UNITED STATES PATENT AND TRADEMARK OFFICE

APPLICATION NO.	FILING DATE	FIRST NAMED INVENTOR	ATTORNEY DOCKET NO.	CONFIRMATION NO.
10/009,696	11/06/2001	John Eric Arnold	DN1999111USA	1392

Office Action Summary

ATTACHMENT # 1

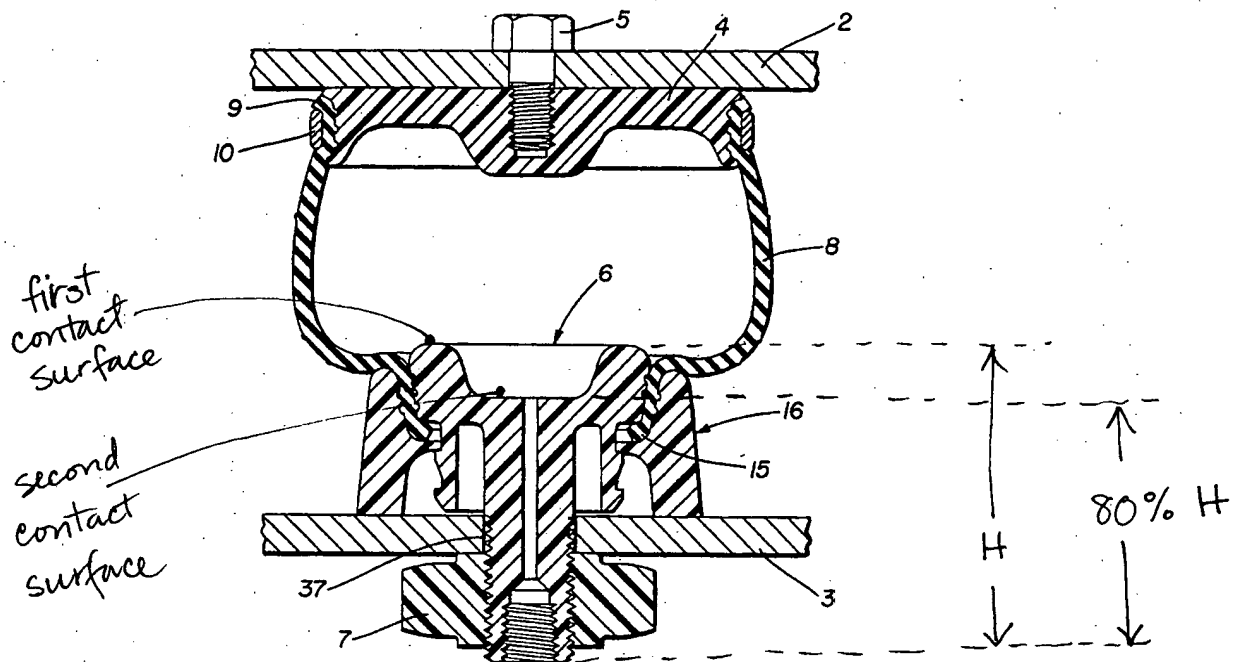
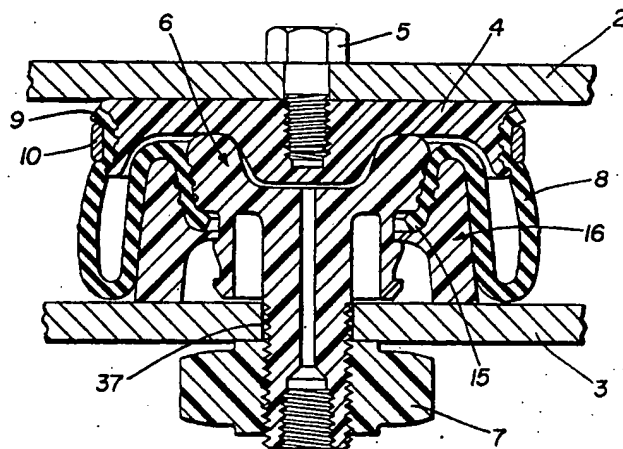
Re: claim 1, Leonard shows an airspring, as in the present invention, comprising: a flexible sleeve 8; first retainer 4; second retainer 6; wherein second retainer 6 having an integral bumper-contact surface (see attachment #1) within the sleeve 8 for axial movement into the sleeve, for contact with the first retainer 4; and for absorbing and transmitting forces generated from such contact.

Re: claims 5 and 6, please see attachment #1 where the Examiner marks the first contact surface, the second contact surface and the proportions of the heights as claimed.
